Re: Detroit Thermal's application # HDC2025-00243 in the Lafayette Park/Mies van der Rohe Historic District. ADDRESS: 1395 ANTIETAM, 1 LAFAYETTE PLAISANCE, 1301 NICOLET PLACE, 1300 NICOLET PLACE, 1301 JOLIET PLACE, 1300 JOLIET PLACE, AND ADJACENT RIGHTS-OF-WAY

I am a resident of the Lafayette Park/Mies van der Rohe Historic District and a member-owner in the Joliet Townhouse Cooperative. I am writing regarding Detroit Thermal's application to install steam infrastructure in our neighborhood. I want to express my strong opposition toward the Commission granting Detroit Thermal either a Certificate of Appropriateness or a Notice to Proceed.

Reference Source: Department of Natural Resources. Washington State. 2014. |

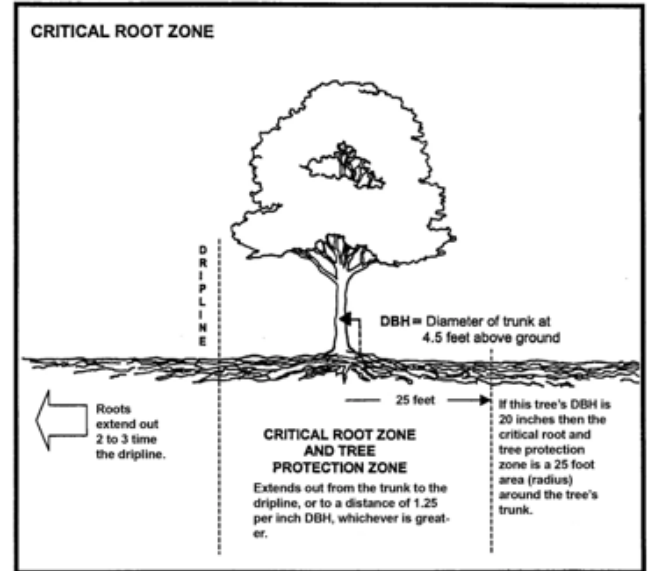
9. **The Critical Root Zone typically extends beyond the dripline of a tree, and is professionally, and often legally, defined as a circle with a 1.0 to 1.5-foot radius for each inch diameter of the trunk of a tree at breast height (DBH).** That means, for a tree with a 20-inch diameter at breast height (DBH), (with a standard of 1.25 feet for each inch of trunk diameter) the Critical Root Zone would be a 25 feet radius from the trunk of the tree (see DNR diagram⁶).
